Application Summary: Proposed development of a new 50,000 square foot office building for the City of Salem Shops Complex.

REGARDING: Class 3 Site Plan Review / Class 2 Adjustment Case No. SPR-ADJ21-20

PROJECT ADDRESS: 1500 Block of 23rd Street SE, Salem OR 97302

SUBJECT: **PUBLIC WORKS RECOMMENDATIONS**
SPR-ADJ21-20 (21-111937-RP)
1457 23rd Street SE
CITY OF SALEM PUBLIC WORKS SHOPS COMPLEX

Figure 25: Design Details of 68" x 134" x 70" Concrete Vault (PGE P/N 39671)

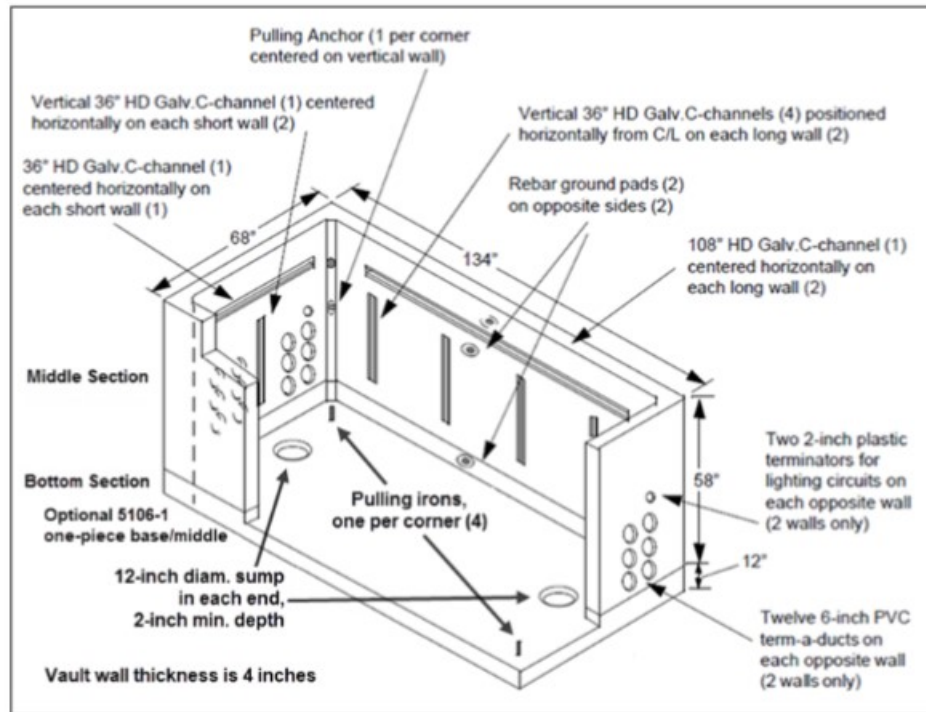
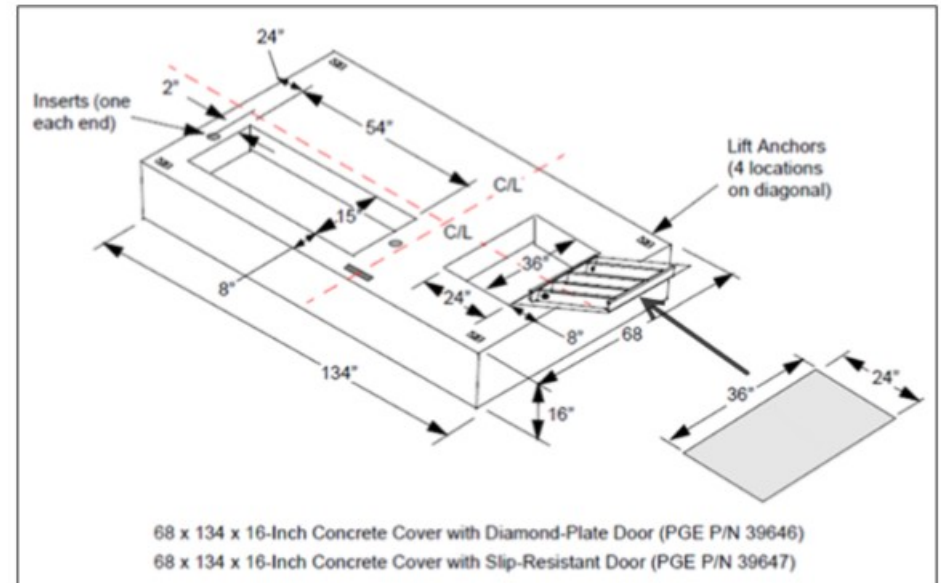
The planned location for the building transformer is likely not large enough for the required working clearance around the equipment/vault. Attached is a page showing the dimensions for the pad/vault on which the transformer will sit (as well as clearance requirements). The vault is 68"x134". The allocated space appears to be slightly deeper than 63-1/2". This dimension precludes the necessary 36" clearance behind the transformer (clear space to existing fence).
